ADDENDUM NO. 2 TO PROJECT NO. 43609

**ELEVATOR, CONSTRUCTION, HVAC AND ELECTRICAL WORK
UPGRADE ELEVATORS
STATE OFFICE BUILDING CAMPUS
BUILDING NO. 2
ALBANY, NY**

April 17, 2013

PARTIAL LIGHTING & POWER PLAN

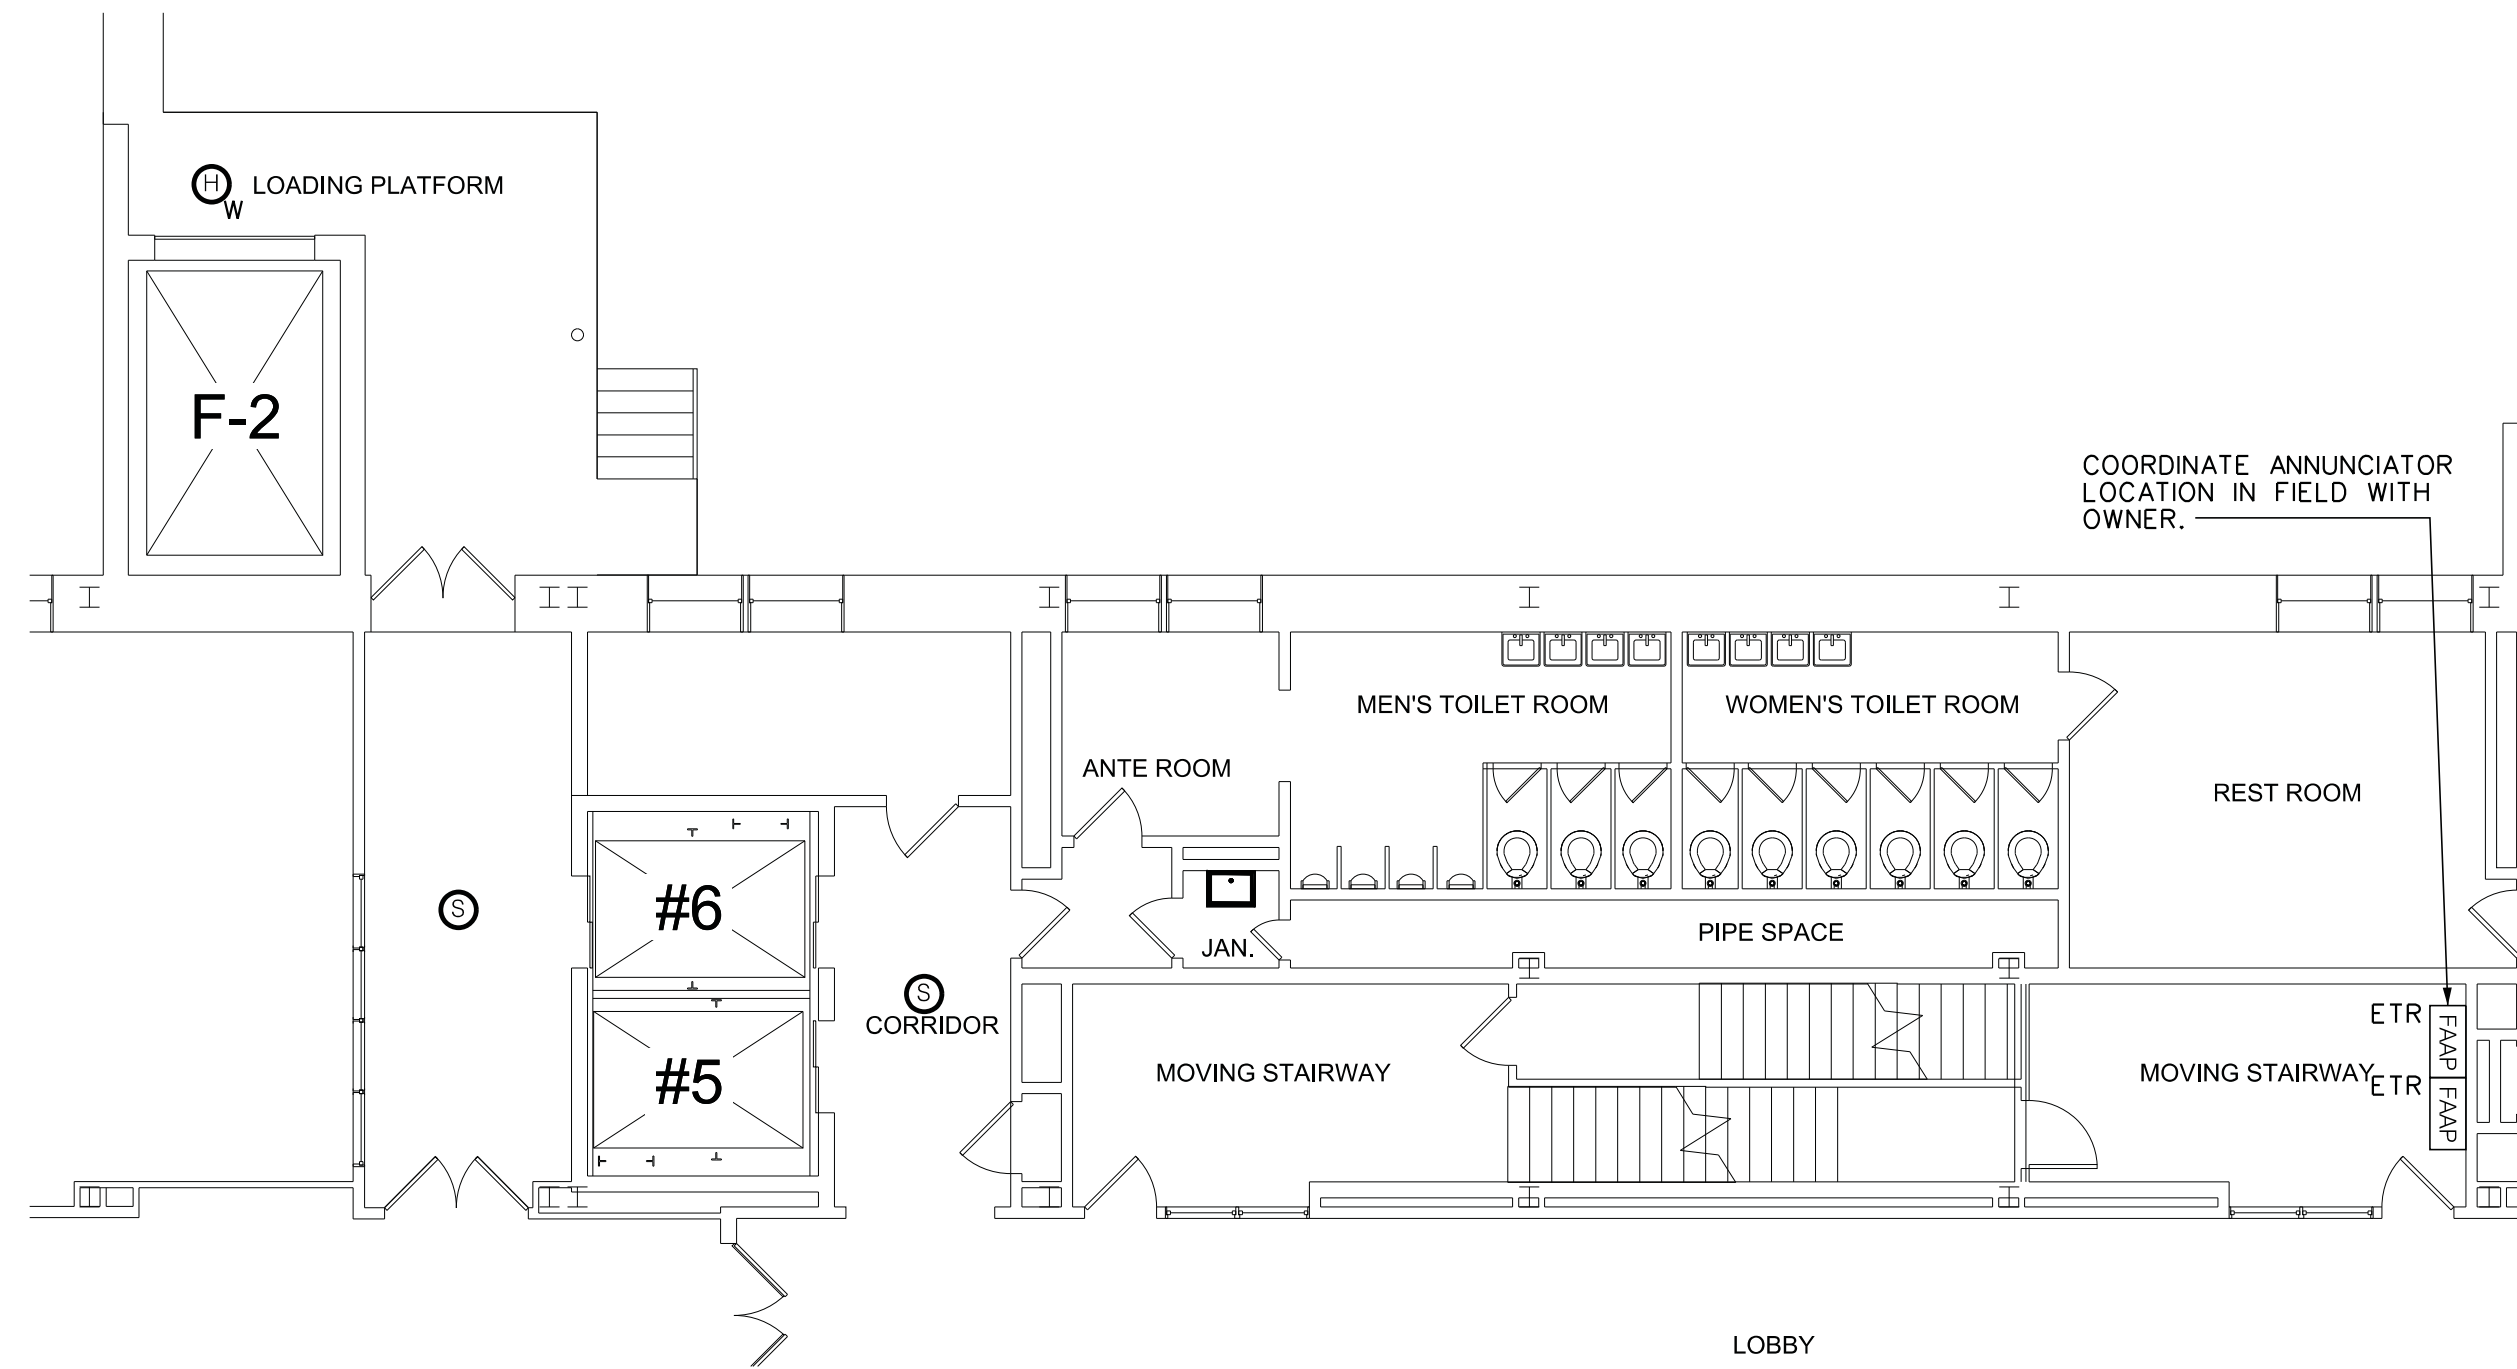
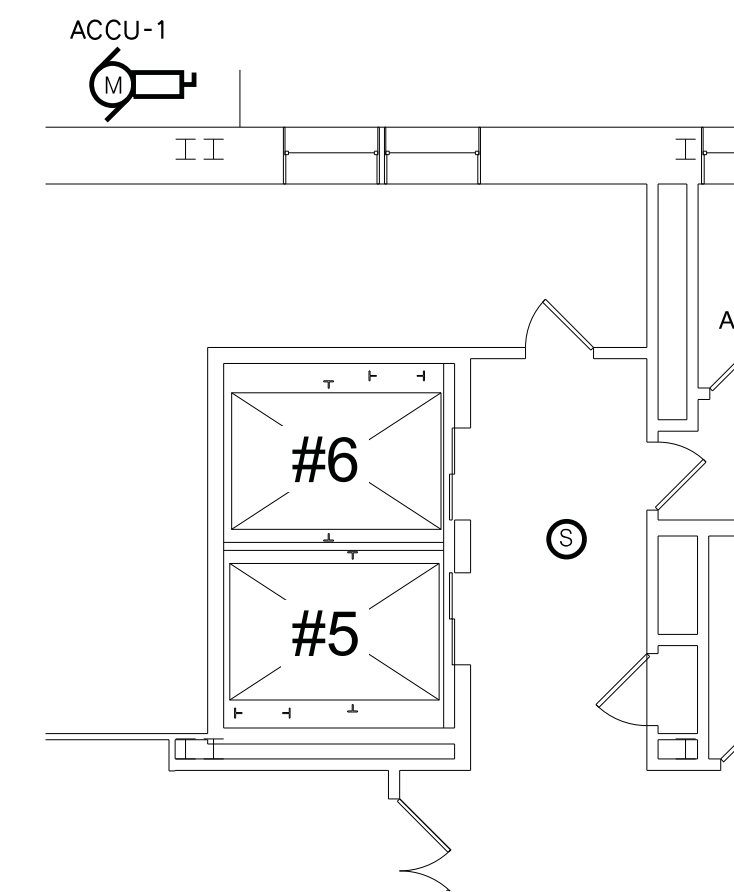
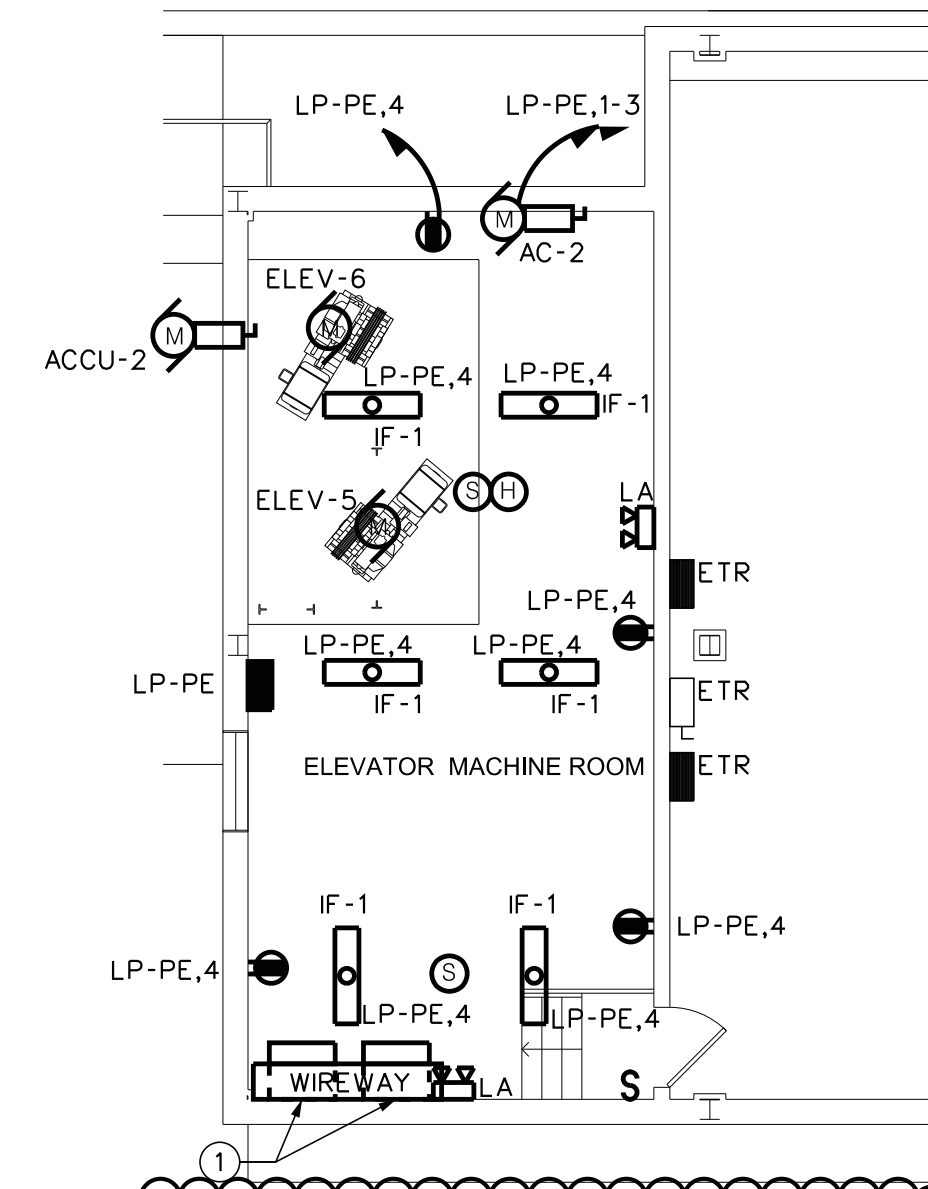
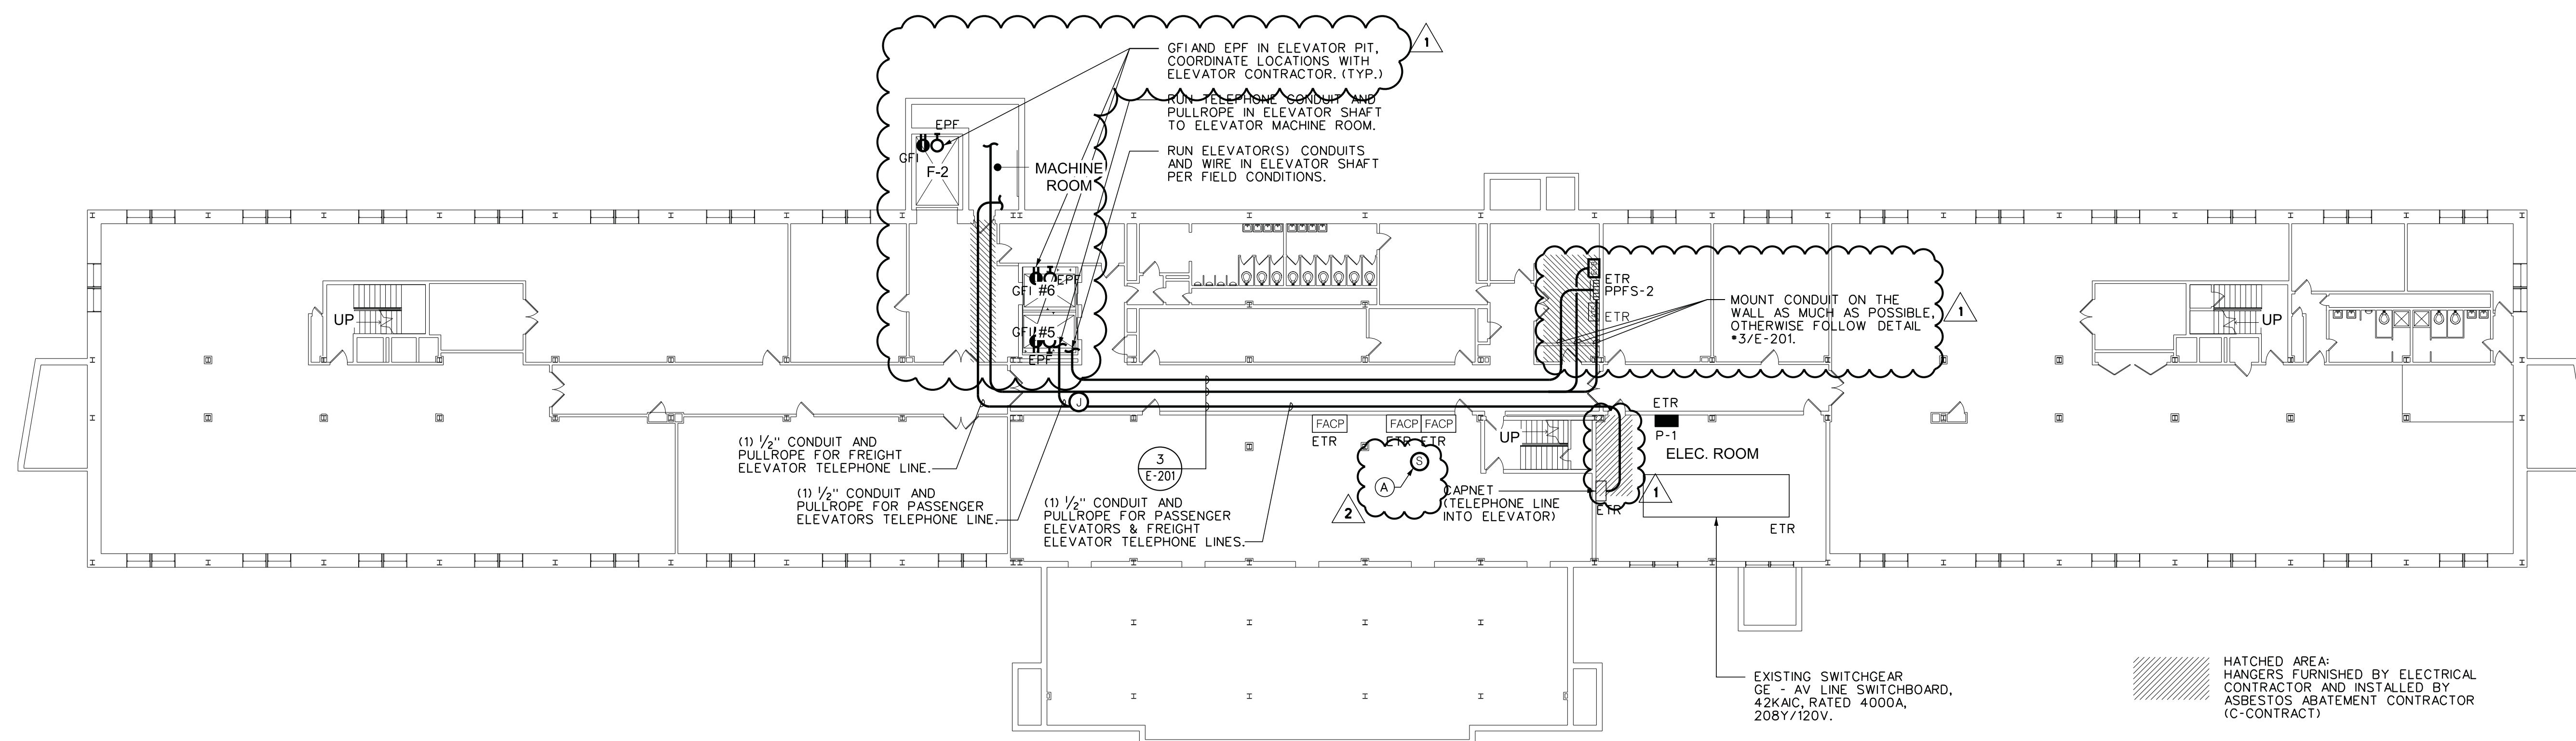
4/E-100 DRAWING NOTES:

- DISCONNECT EXISTING 3/4" EMT CONDUIT THAT RUNS THROUGH THE DOOR FRAME. REROUTE THIS CONDUIT THROUGH NEW OPENING ABOVE DOOR. PROVIDE 2 HOUR FIRE STOPPING AT OPENING.
- DISCONNECT AND RECONNECT EXISTING 3/4" EMT CONDUIT THAT RUNS ALONG THE DOOR FRAME - PENDING FIELD CONDITIONS.

4/E-100 DRAWING NOTES:

- PROVIDE COOPER BUSSMANN POWER MODULE, TYPICAL OF 2. MODEL #PS2T20R1KGN2BF3
